LAKE TAHOE COMMUNITY COLLEGE
Student Housing Building Project
RFP #22-23-002
Addendum #1

PROJECT: RFP #22-23-002 – Student Housing Building Project

DATE: June 22, 2023

Description(s): Revised Increment 1 Drawings to show:

3 ENLARGED UTILITY TRANSFORMER PAD
SCALE: 1/4" = 1'-0"

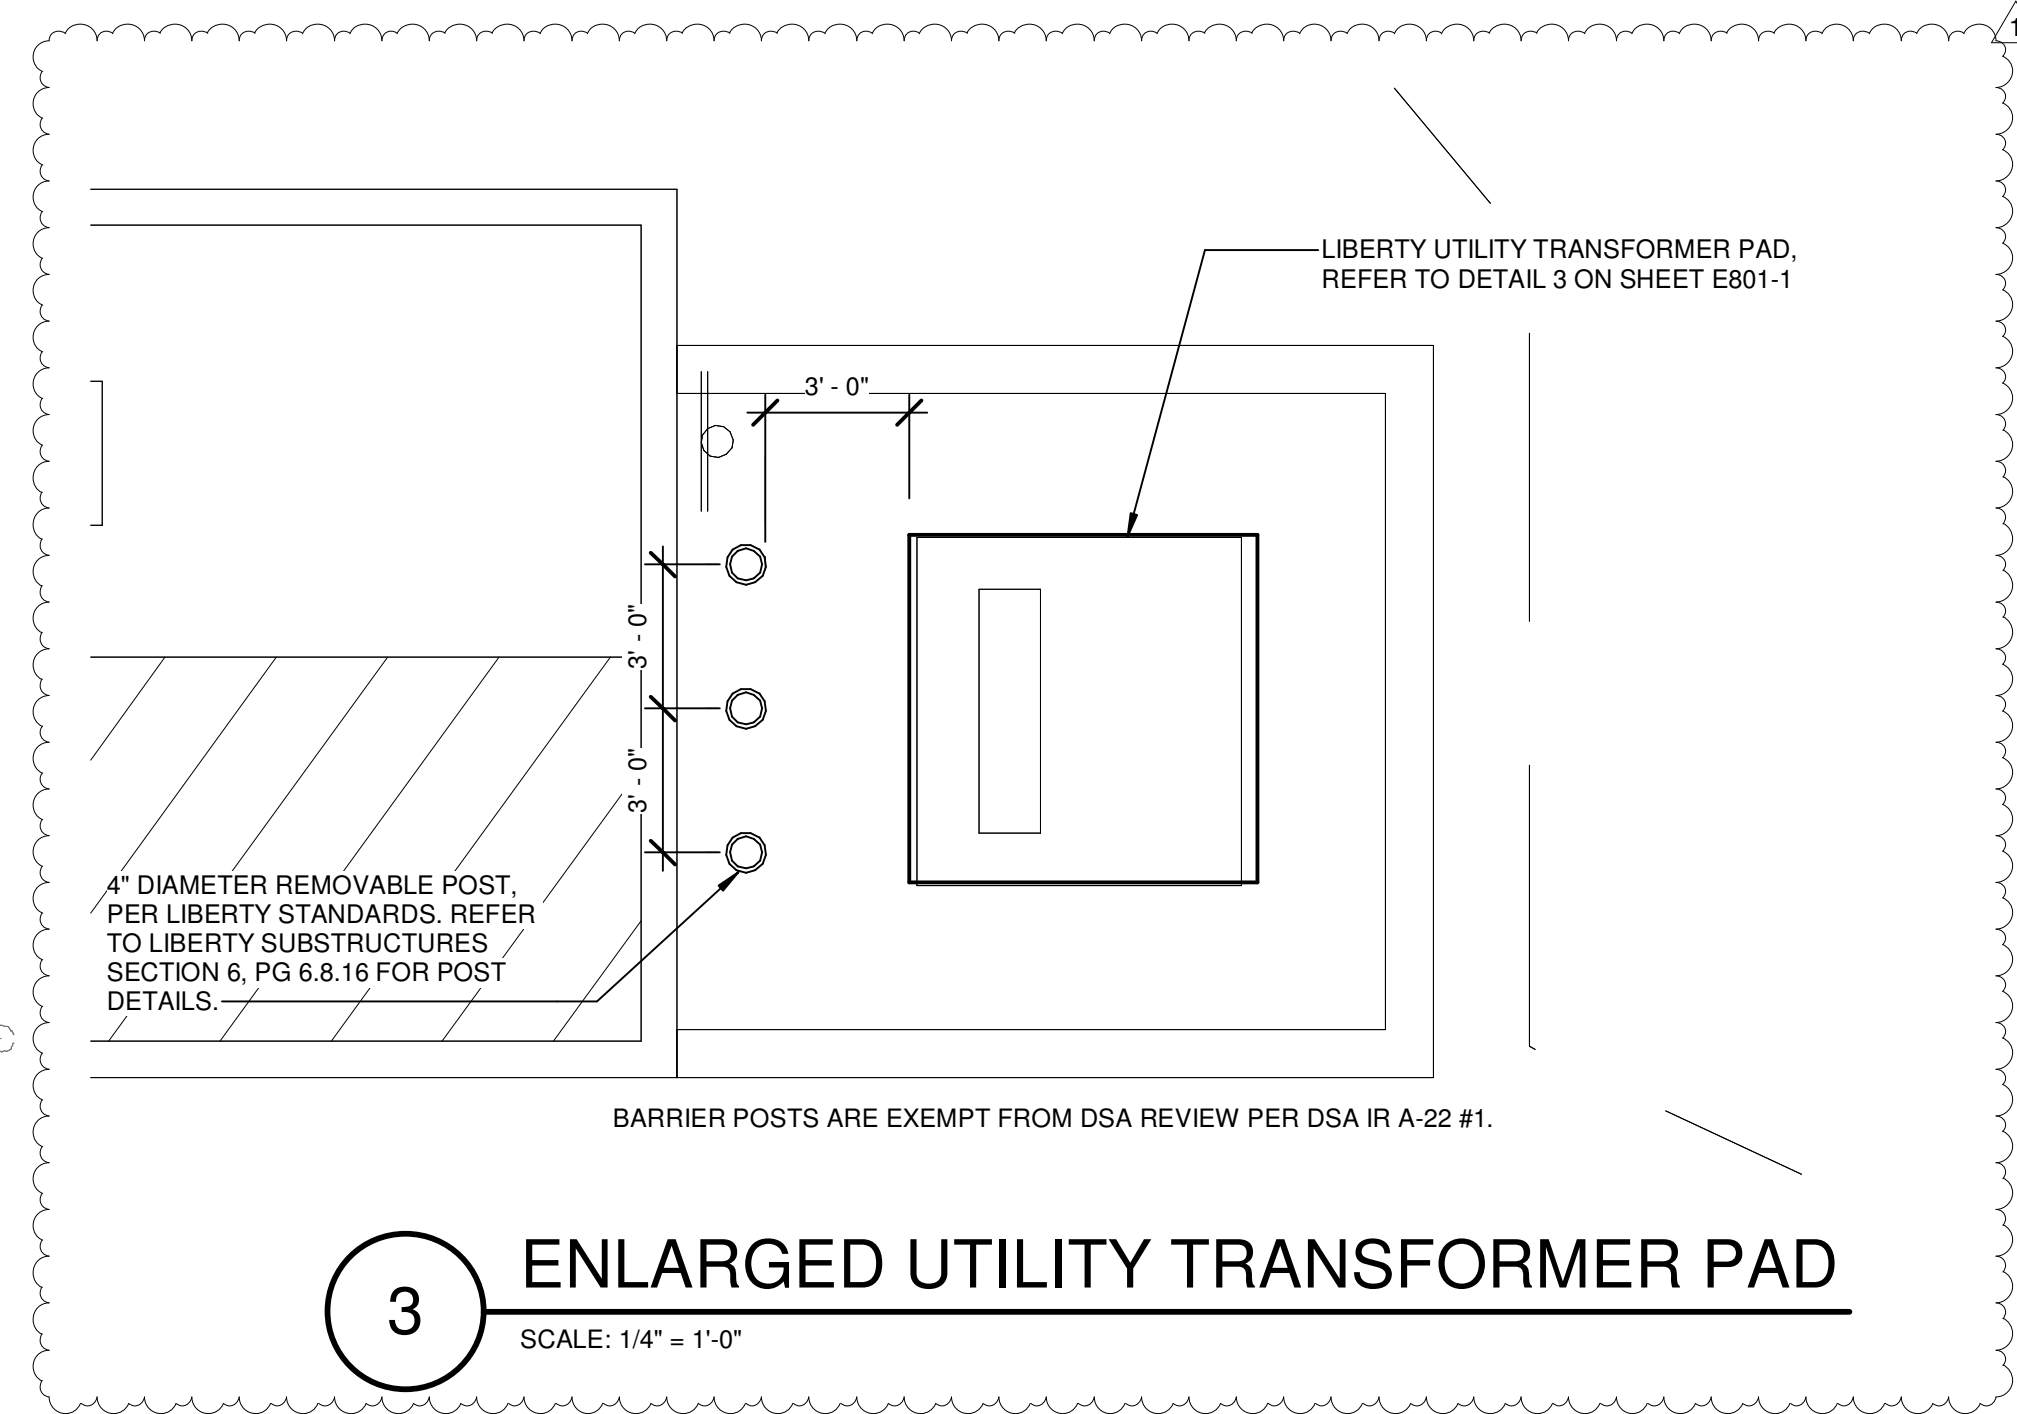
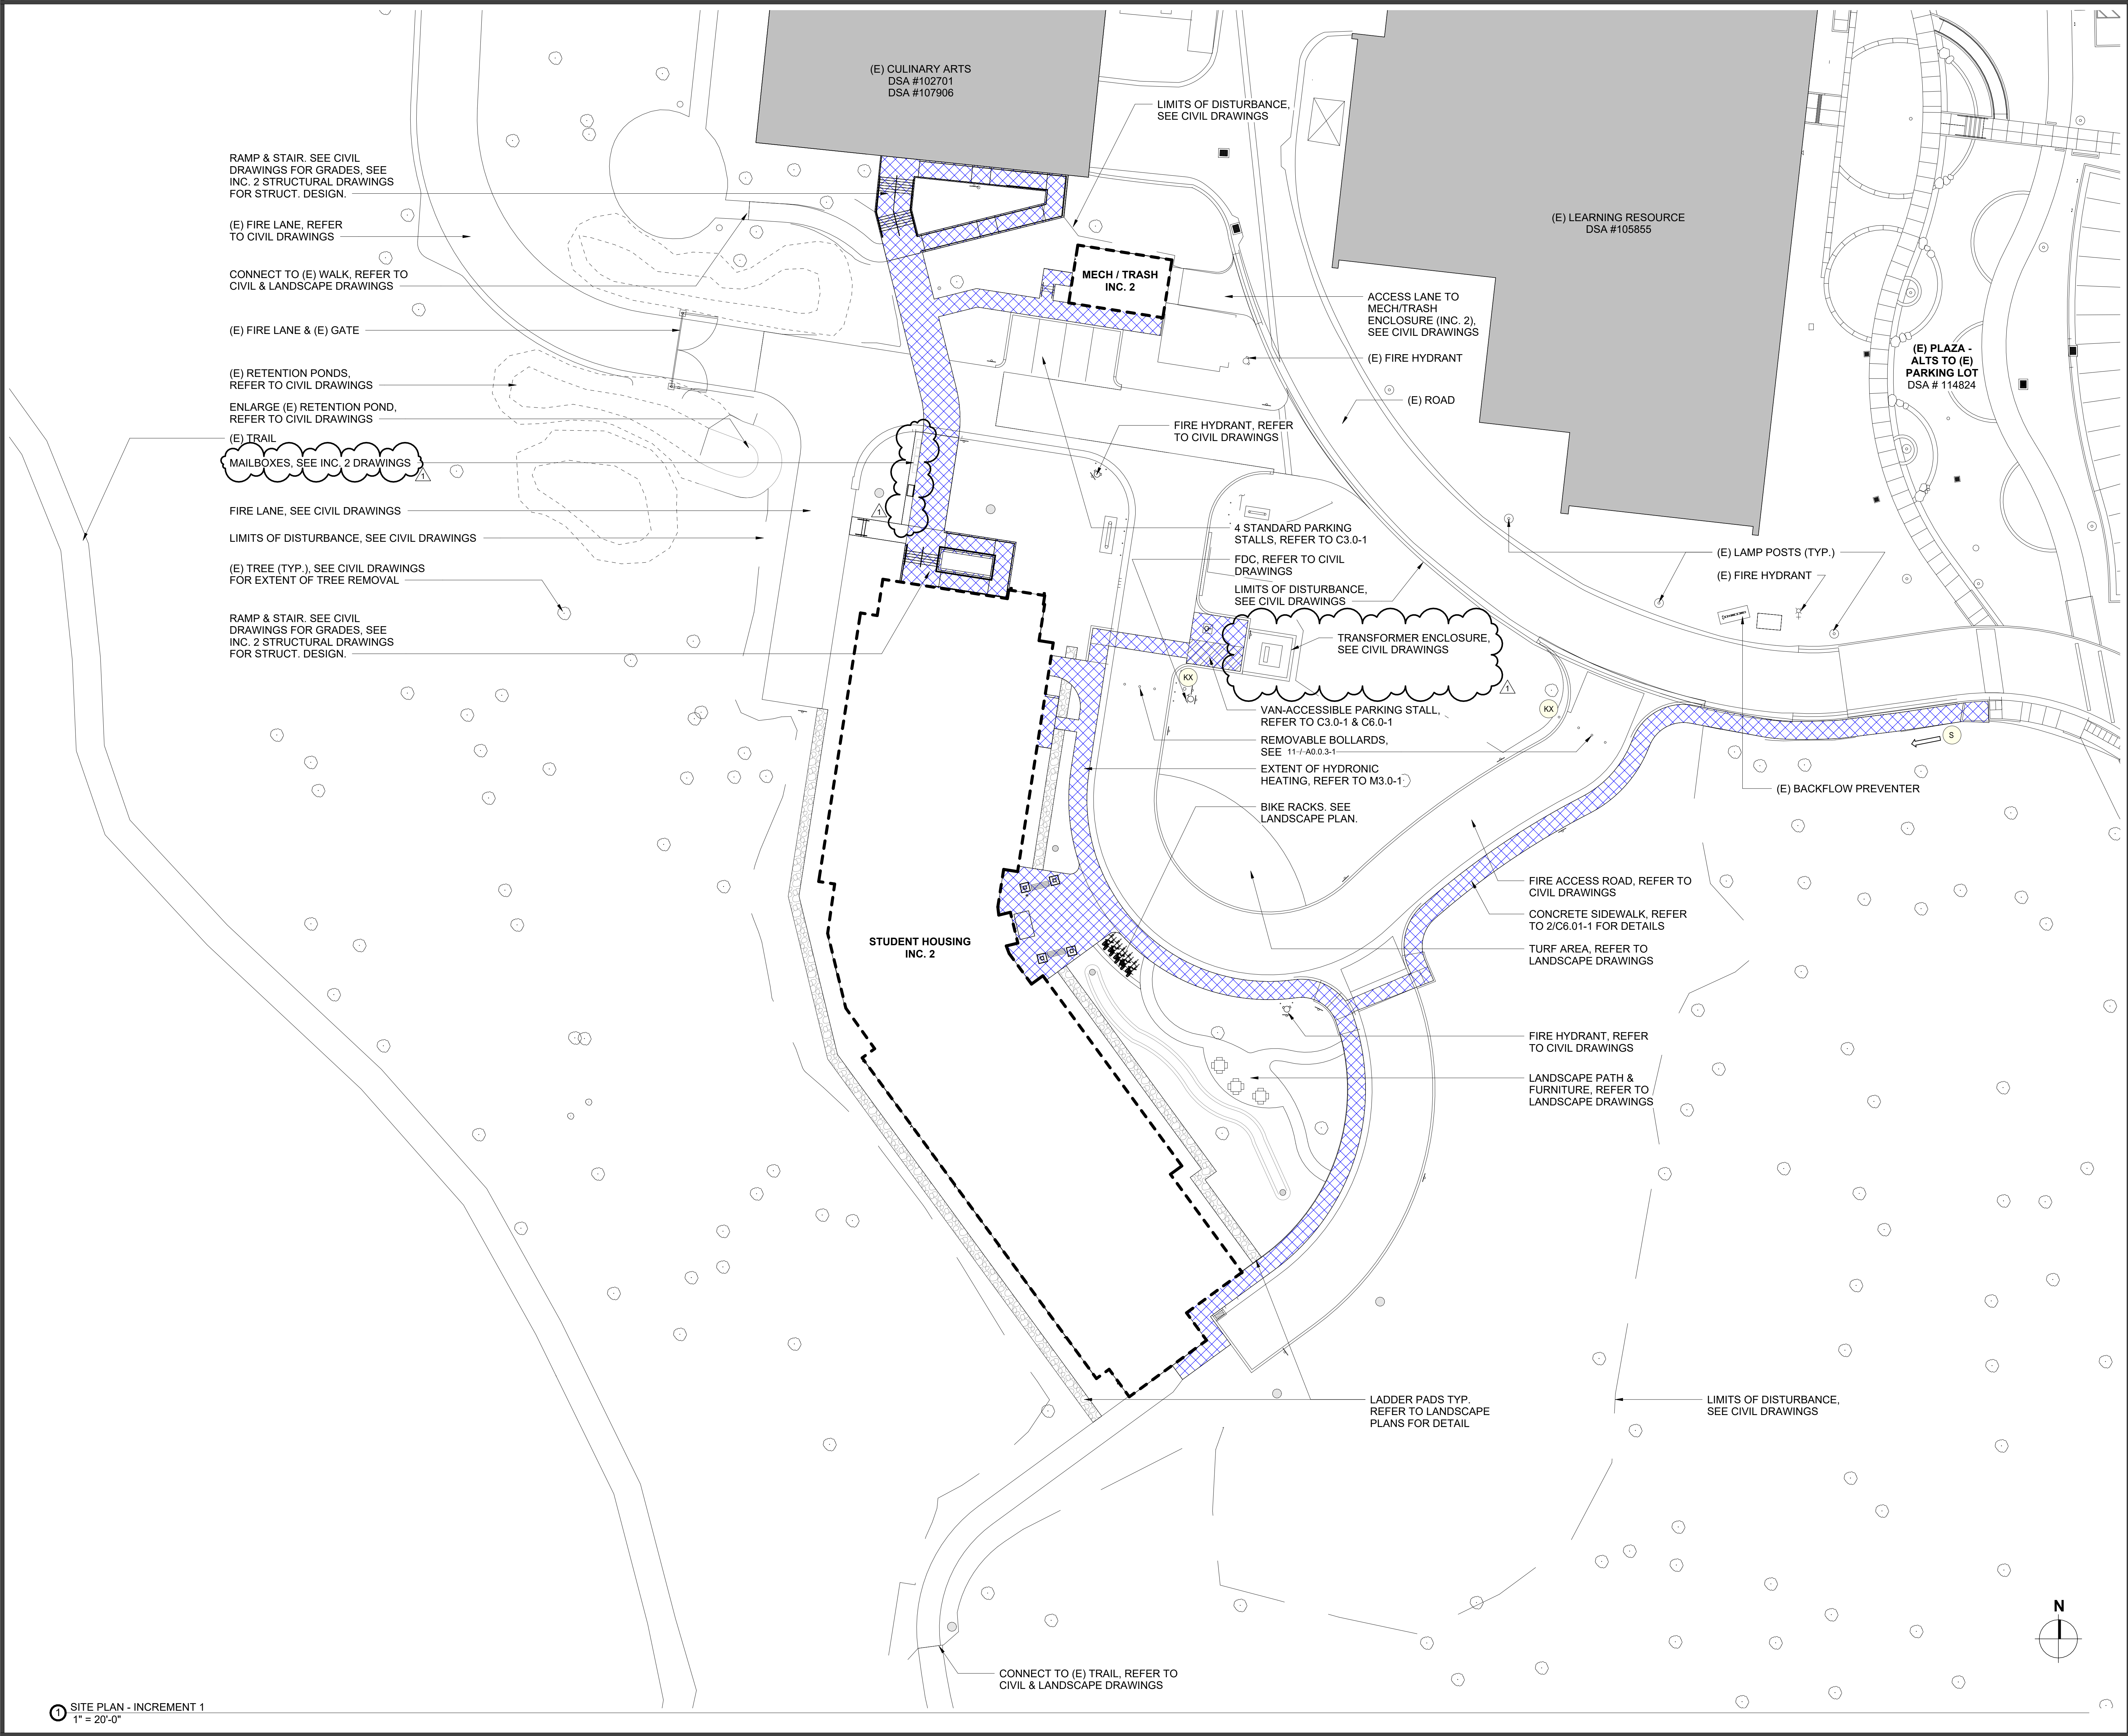
- Minor revisions to existing conditions.
- Relocation of the utility transformer based on direction from Liberty Utilities and associated work.
- Minor revision to a pedestrian path to accommodate mailboxes and associated work.
- Minor modifications to landscape plantings.
